UNITED STATES PATENT AND TRADEMARK OFFICE

APPLICATION NO.	FILING DATE	FIRST NAMED INVENTOR	ATTORNEY DOCKET NO.	CONFIRMATION NO.
10/789,689	02/27/2004	Takehiro Okanaka	KASAP047	9344
22434	7590	03/01/2005	EXAMINER	
BEYER WEAVER & THOMAS LLP P.O. BOX 70250 OAKLAND, CA 94612-0250			NGUYEN, XUAN LAN T	
			ART UNIT	PAPER NUMBER
			3683

Office Action Summary

DETAILED ACTION

FIG. 5

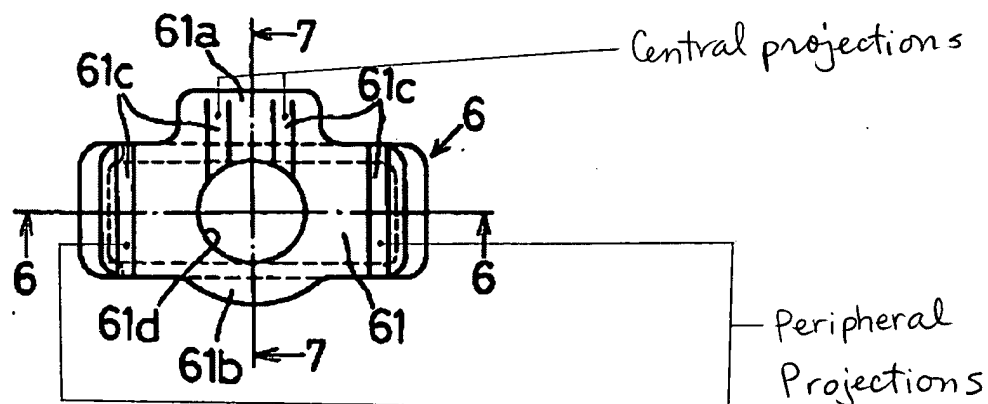
Re: claim 6, figure 5 of Tanahashi shows the arrangement of the central projections and the peripheral projections as claimed.
